Subject: AES Highgrove Project (06-AFC-2)  
Data Response, Set 1A

# **AES HIGHGROVE PROJECT (06-AFC-2)**

## **DATA RESPONSE, SET 1A**

**FIGURE LU39-1**  
**SURVEYED BOUNDARIES OF**  
**NEW PARCEL**  
 AES HIGHGROVE  
 GRAND TERRACE, CALIFORNIA  
**CH2MHILL**

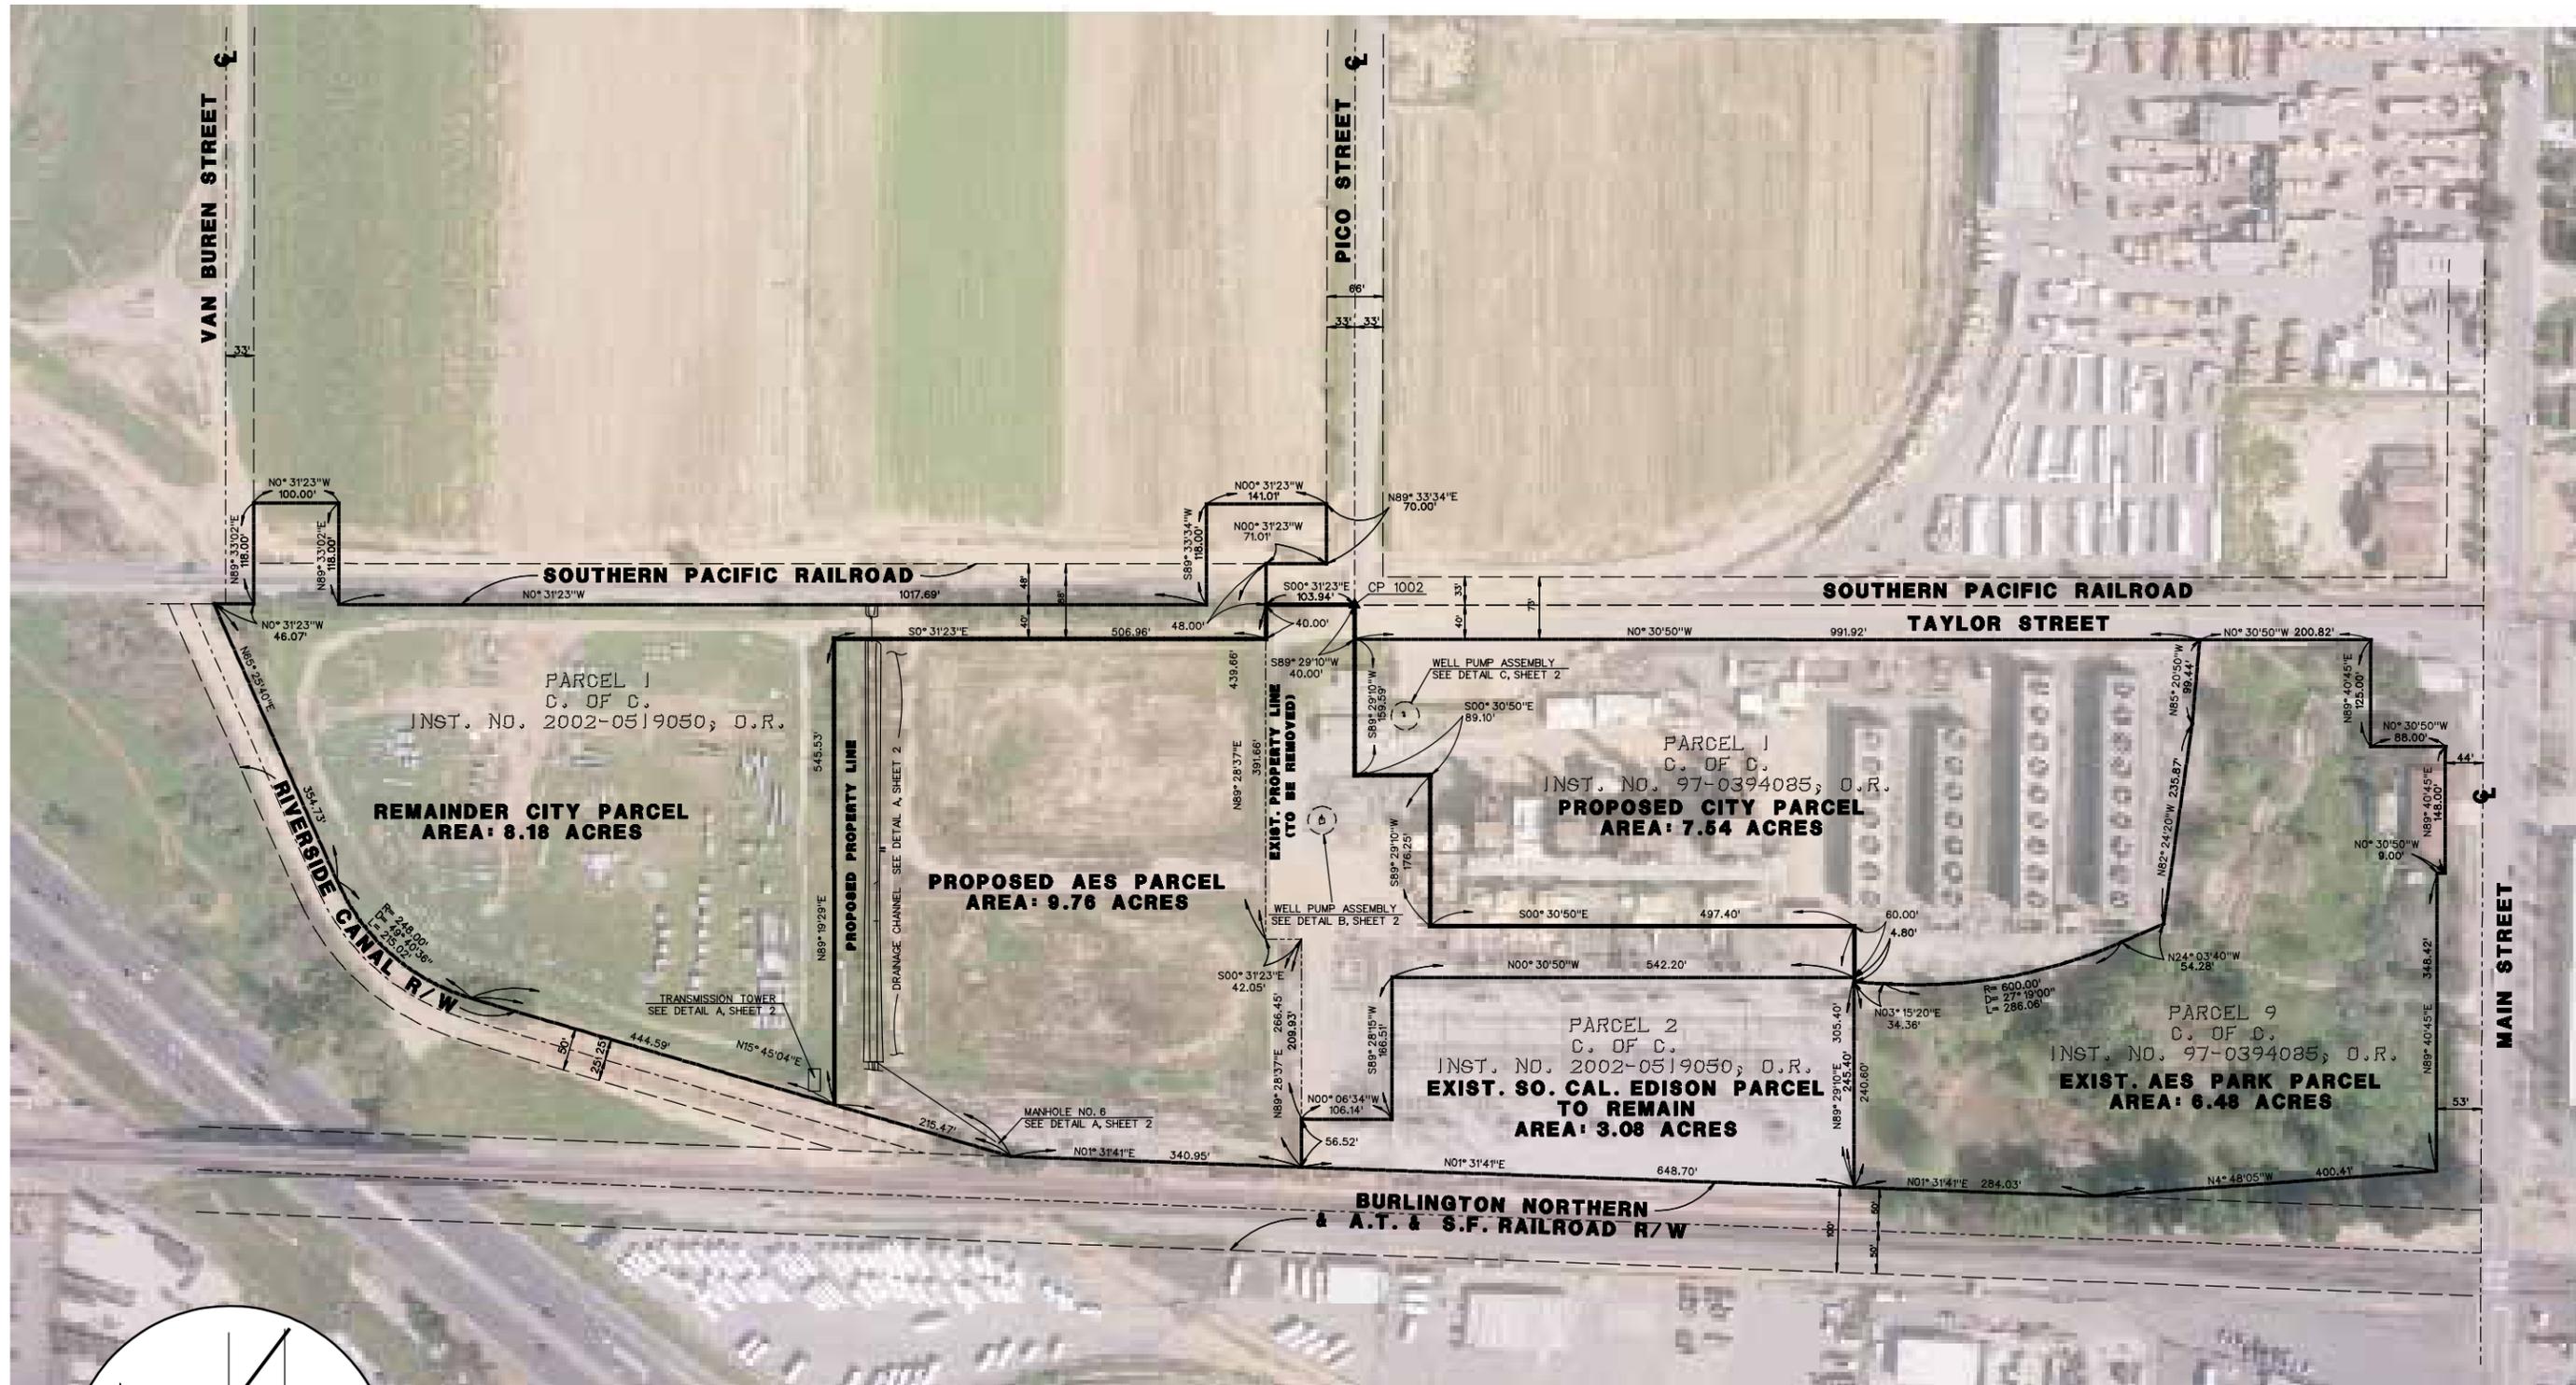
39. Please provide the legal description for the newly created parcel and revised parcel map.

**Response:** A survey of the proposed boundaries for the newly created parcel is attached as Figure LU39-1. A final survey and accompanying legal description will be prepared just prior to filing the application described above.

**FIGURE LU40-1**  
**STREET CROSS SECTIONS**  
 AES HIGHGROVE  
 GRAND TERRACE, CALIFORNIA

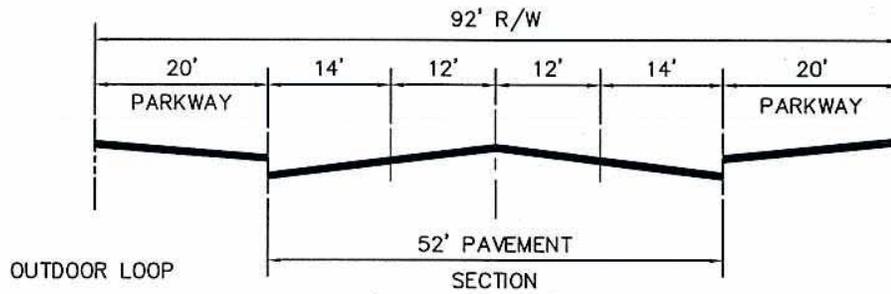
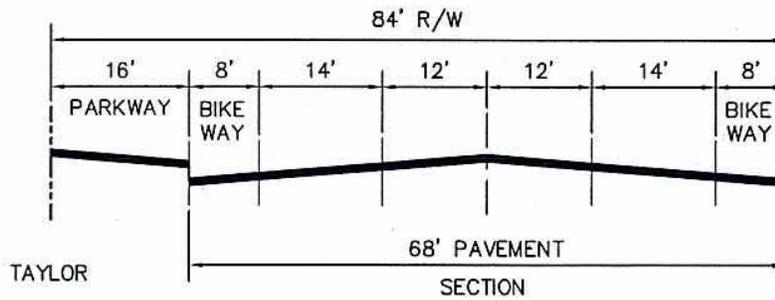
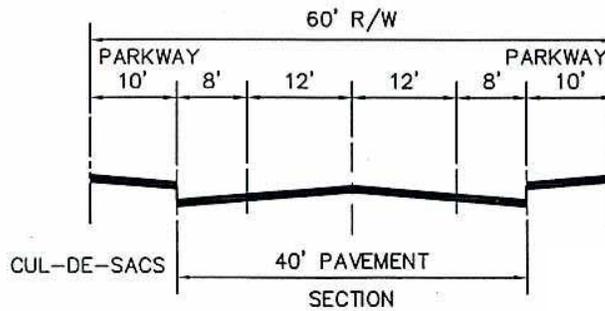
40. Revise Figure 2.2-1 General Arrangement Map in the application to provide the:

Figure LU40-1 shows the proposed road cross section. The Project proposed a landscaping plan in the AFC to minimize visual impacts from the plant. The landscaping would consist of redwoods to be located on the berm and redbuds that would be located in the parkway. The proposed landscaping is consistent with the City's Specific Plan landscaping guidelines for the property north of the proposed project.

**FIGURE VR 69-1**  
**SITE LINES FROM PROPOSED**  
**HIGH SCHOOL**  
 AES HIGHGROVE  
 GRAND TERRACE, CALIFORNIA  
**CH2MHILL**

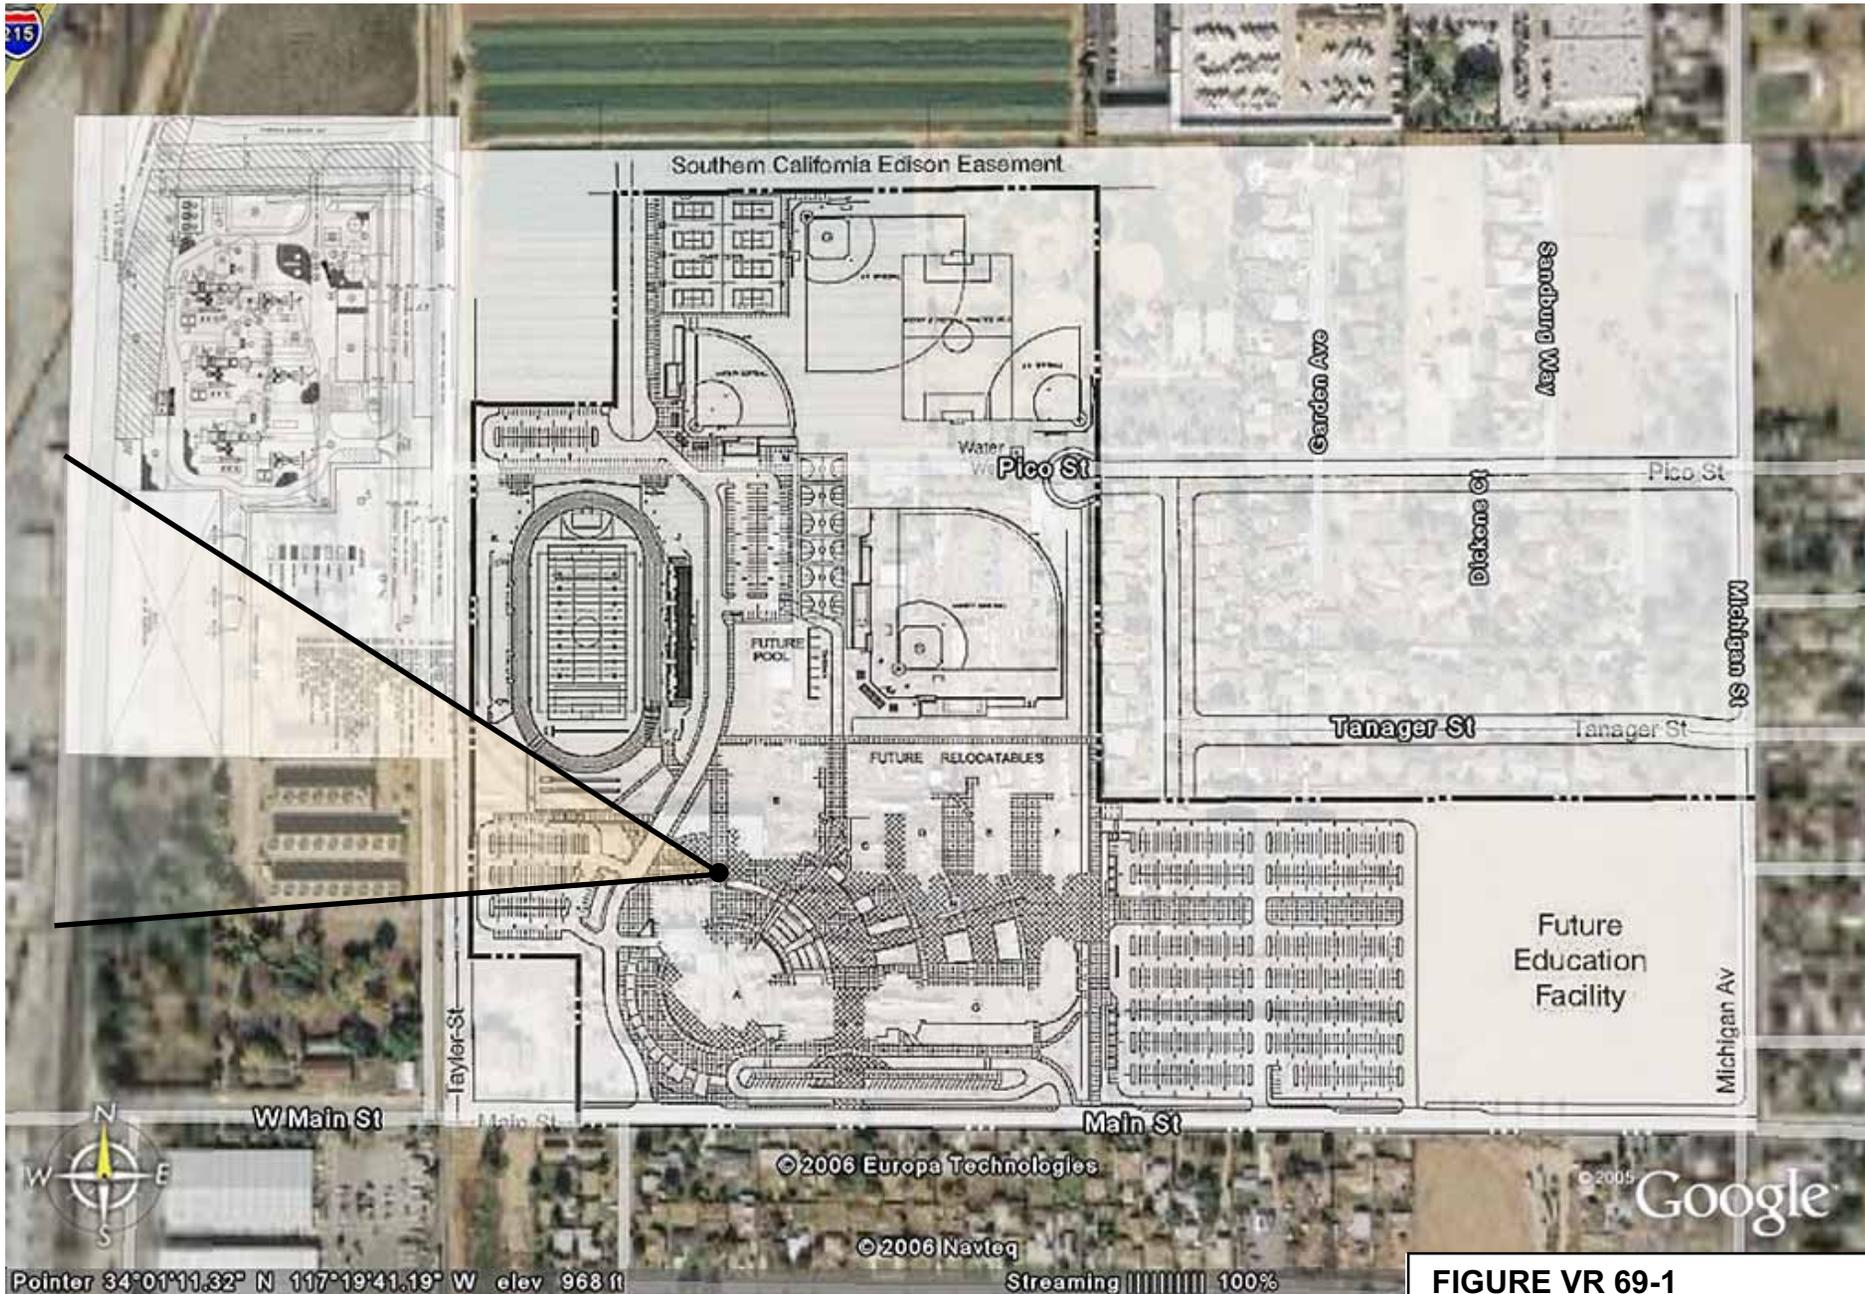
69. Please provide a representative KOP visual simulation from the proposed school site looking towards the HP to illustrate the potential visual impact from the proposed school entrance.

**Response:** From the school site plan, it appears that the main entrance to the school is between Buildings A and G. At that point the entire power plant would be blocked by school buildings. During most of the day, students will be within the school complex (i.e., the open area between Buildings A through G). As shown in Figure VR69-1, most views of the plant from that location will be blocked by the school buildings and sports stadium.

**FIGURE VR70-1**  
**SIMULATION OF OLD AND NEW PLANTS**  
AES HIGHGROVE  
GRAND TERRACE, CALIFORNIA

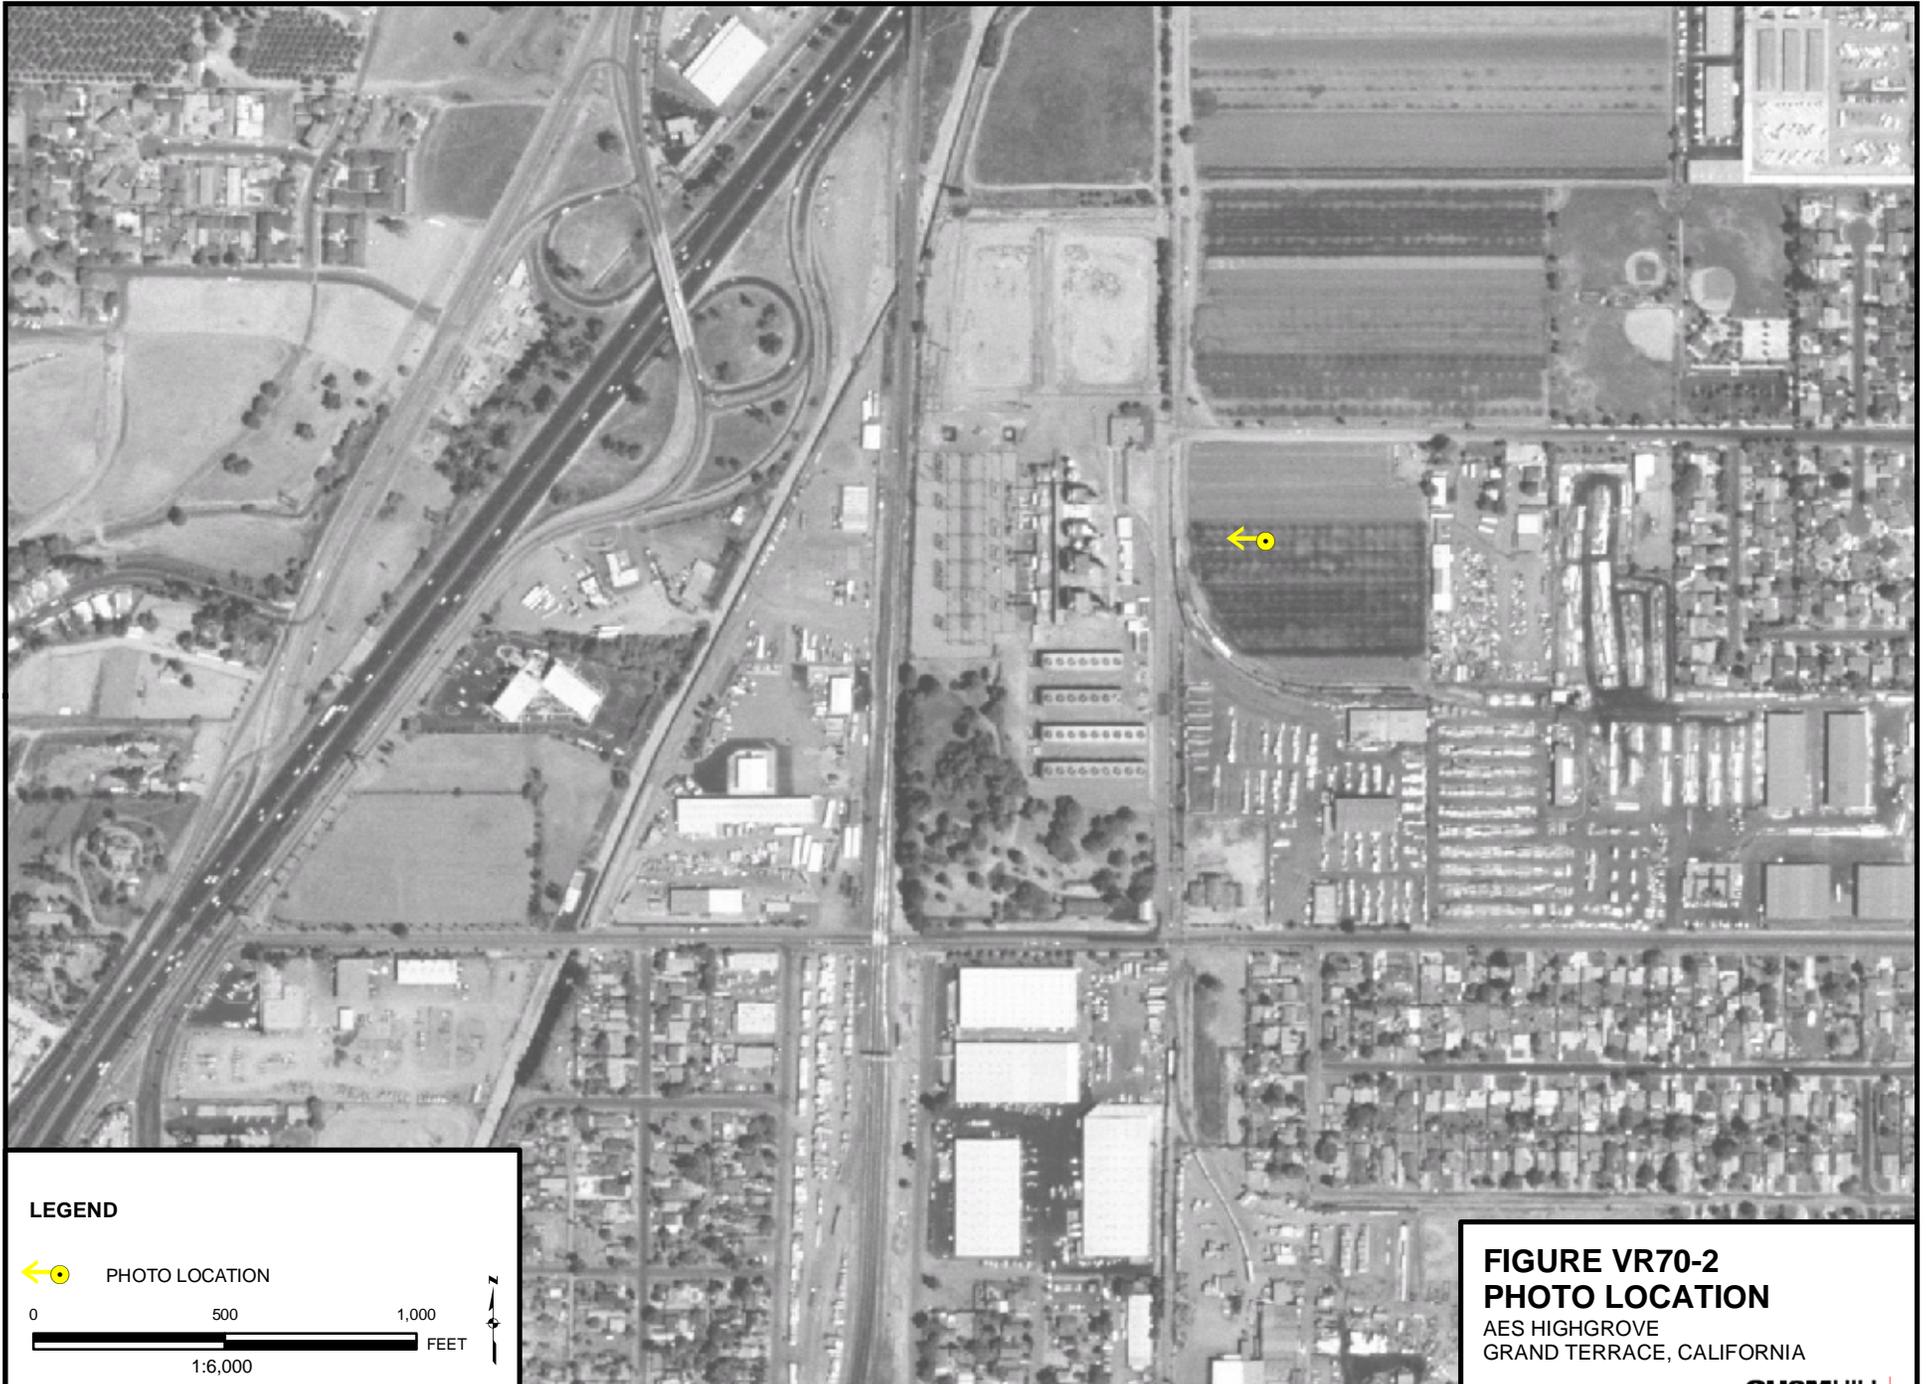
70. Please provide full-page color photographic reproductions of the existing site and a simulation of the proposed project in the existing setting, including the proposed berm and tree sizes at five years after planting.

**Response:** Figure VR70-1, provides a panoramic visual simulation from the location of the proposed stadium (see Figure VR70-2, for photo location and direction).. This simulation does not include the school structures but presents, by fading out the image, a comparison between the existing plant and the proposed Highgrove project<sup>7</sup>. As shown in the figure, the proposed Highgrove has substantially less bulk and is screened from most views. In addition, to provide further screening of the project from southern views, the block wall will be wrapped around on the southern end of the plant as shown in Figure 2.2-1R.
